HISTORIC AND DESIGN REVIEW COMMISSION

HDRC CASE NO: 2021-051
ADDRESS: 315 W HUISACHE AVE
LEGAL DESCRIPTION: NCB 3001 BLK 3 LOT E 47 OF 19
ZONING: R-4
CITY COUNCIL DIST.: 1
DISTRICT: Monte Vista Historic District
APPLICANT: Larry Curtis/CURTIS LARRY G & JOSEPHINE F
OWNER: Larry Curtis/CURTIS LARRY G & JOSEPHINE F
TYPE OF WORK: Front yard fence installation, irrigation installation, walkway modifications
APPLICATION RECEIVED: January 25, 2021
60-DAY REVIEW: Not applicable due to City Council Emergency Orders
CASE MANAGER: Rachel Rettaliata

REQUEST:

Historic and Design Review Commission
Design Review Committee Report

FENCE LOCATION PLOT

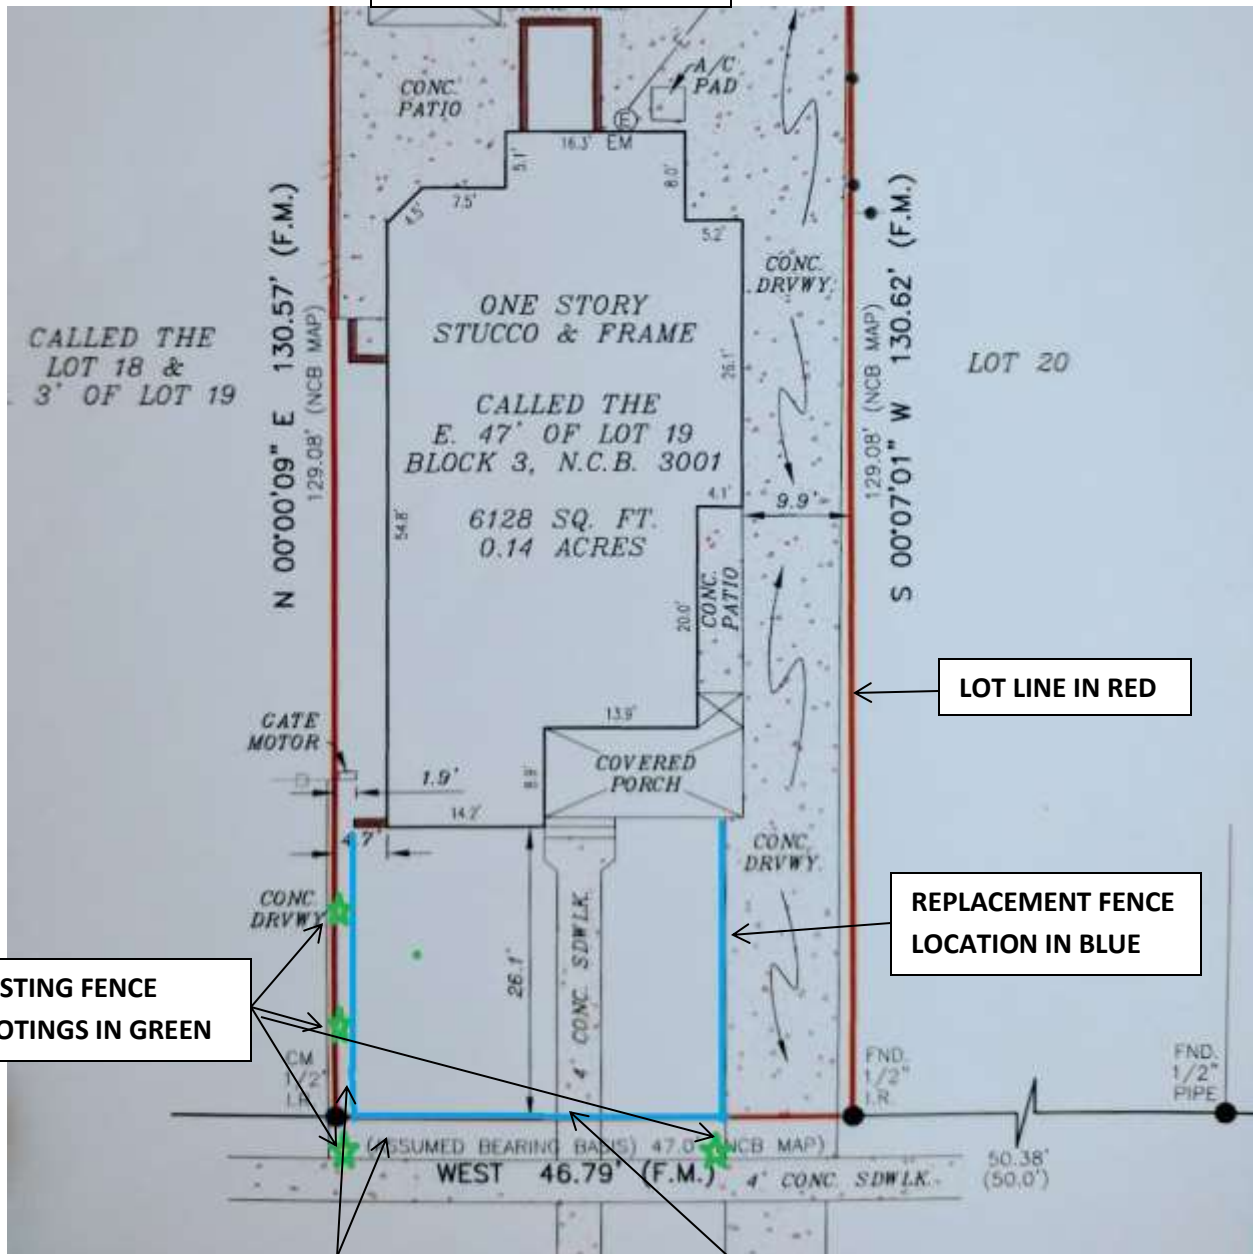
- c. FENCE DESIGN AND HEIGHT – The applicant has proposed to install a 4-foot-high wrought iron front yard fence with a driveway gate and pedestrian gate. Guideline 2.B.i for Site Elements states that new fences and walls should appear similar to those used historically within the district in terms of their scale, transparency, and character. Design of fence should respond to the design and materials of the house or main structure. According to Guideline 2.B.iii for Site Elements the height of new fences and walls within the front yard should be limited to a maximum of four feet. The appropriateness of a front yard fence is dependent on conditions within a specific historic district. New front yard fences should not be introduced within historic districts that have not historically had them. While the design and height of the proposed front yard fence is appropriate for the Monte Vista Historic District, the streetscape along W Huisache features predominantly open yards or yards landscaped with box hedges or short retaining walls. The applicant has provided evidence of existing wrought iron fences at nearby properties; however, these two existing fences are installed on properties in proximity to a non-residential property. Staff finds the proposal inconsistent with the Guidelines.

- d. FENCE LOCATION – The applicant has proposed to install the 4-foot-high wrought iron fence around the perimeter of the front yard, 4 feet from the sidewalk. The proposed front yard fence will turn in at the driveway and terminate in a driveway gate at the front façade wall plane. Guideline 2.B.ii for Site Elements states that fence or wall installation should be avoided in a location where one did not historically exist, particularly within the front yard. The appropriateness of a front yard fence or wall is dependent on conditions within a specific historic district. New front yard fences or wall should not be introduced within historic districts that have not historically had them. The applicant has provided evidence that a front yard fence previously existed on the property, due to the presence of fence footings. The previously existing fence was most likely installed prior to 2007 and was most likely a nonconforming chain link fence. Staff does not find that a front yard fence is appropriate for this block of W Huisache. If a front yard fence is installed on the property, staff finds the location and placement of the driveway gate appropriate due to the unique site conditions of the property.

- i. That the proposed driveway gate is located behind the front façade wall plane. The applicant is required to submit an updated site plan showing the location of the driveway gate behind the front façade wall plane to staff for review and approval.
- ii. That the final construction height of the approved gate and fencing may not exceed the maximum height of 4 feet as approved by the HDRC at any portion of the fence. Additionally, the gate and fencing must be permitted and meet the development standards outlined in UDC Section 35-514.

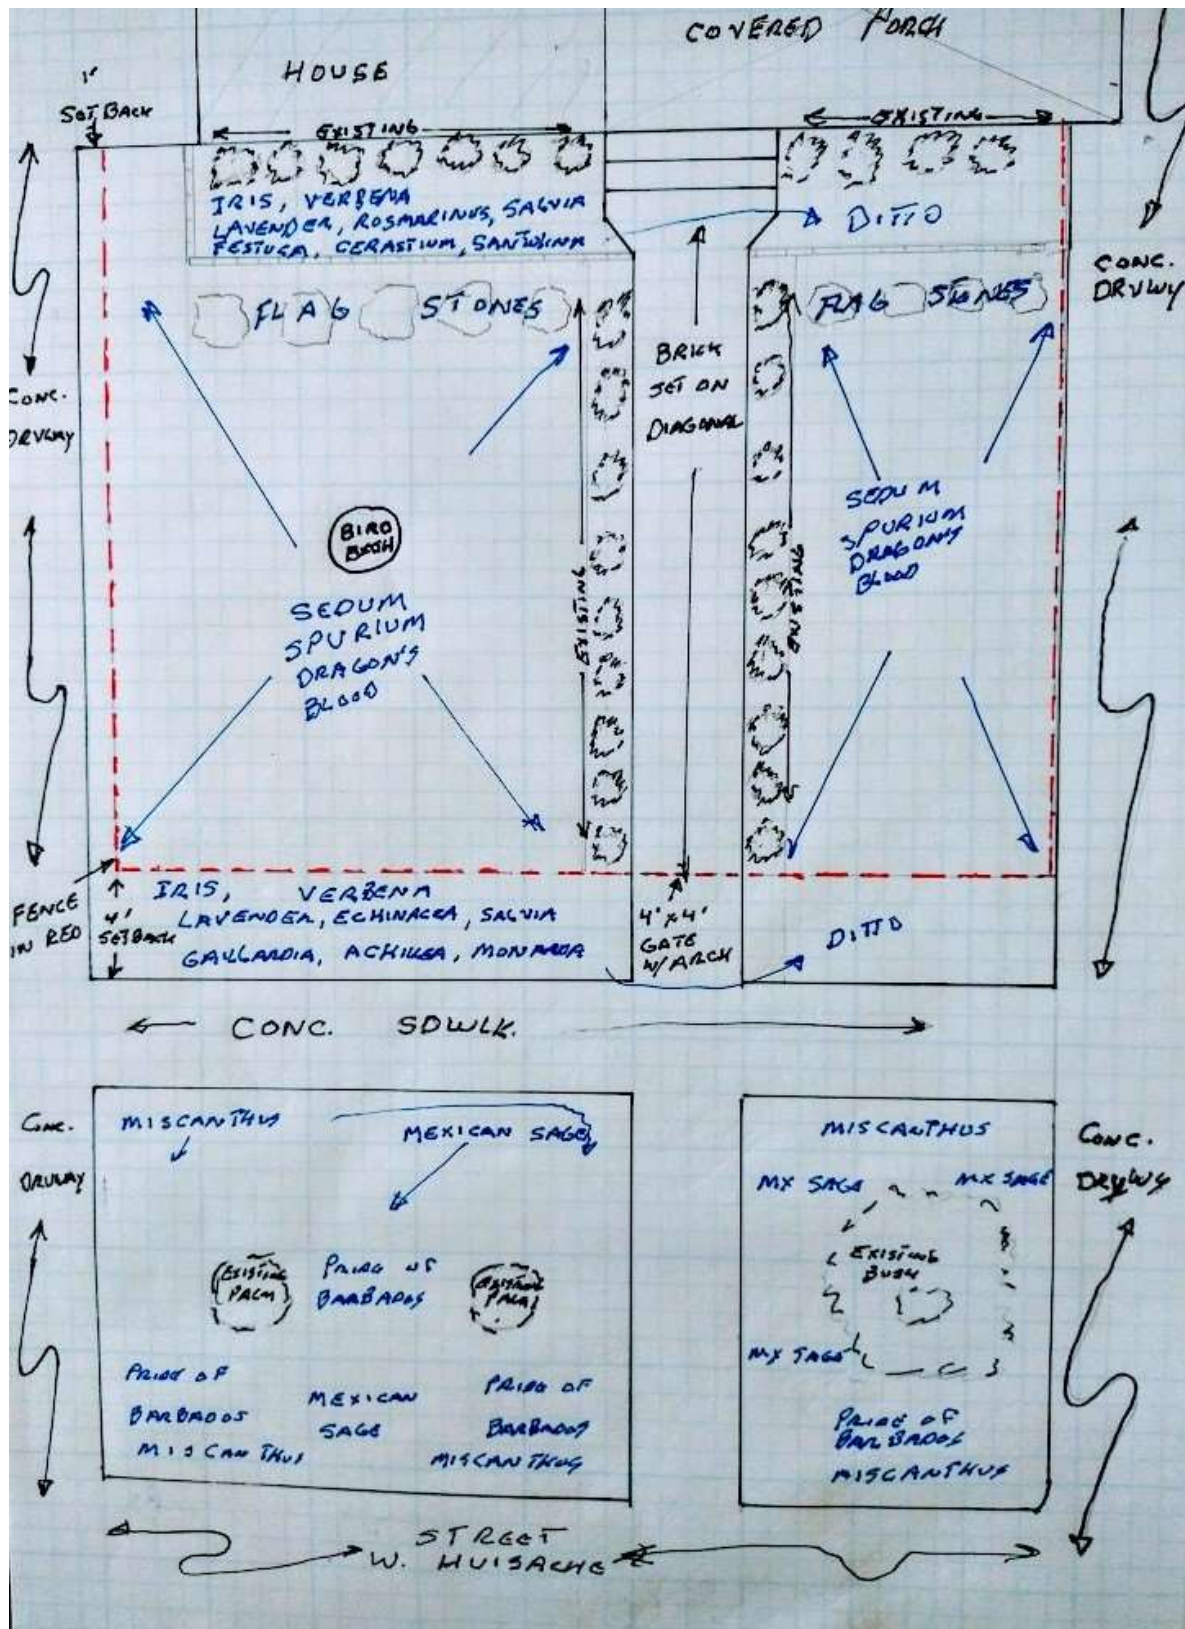
- e. FRONT WALKWAY REPLACEMENT – The applicant has proposed to replace the existing concrete front walkway with patterned brick pavers. Guideline 5.A.i for Site Elements states that historic sidewalk and walkway paving materials—often brick or concrete—should be retained and repaired in place. According to Guideline 5.A.ii for Site Element, when replacing those portions of sidewalks or walkways that are deteriorated beyond repair, every effort should be made to match existing sidewalk color and material. Staff finds the proposal inconsistent with the Guidelines.

JF: I did look at google earth and I see the properties nearby have brick, looking at your home – the detailing is simple and elegant, and I think adding a brick walkway to the front of it would detract from the design and character of your home. The other homes are large and are more ornate, those may be more fitting for those types of homes. For the style of your home and due to the elegant detailing, I think that a brick walk would detract from it.

Item 2, staff does not recommend approval of the brick walkway installation based on finding e. Staff recommends that the applicant repairs and replaces the existing concrete walkway with in-kind material and matches the existing footprint and design.
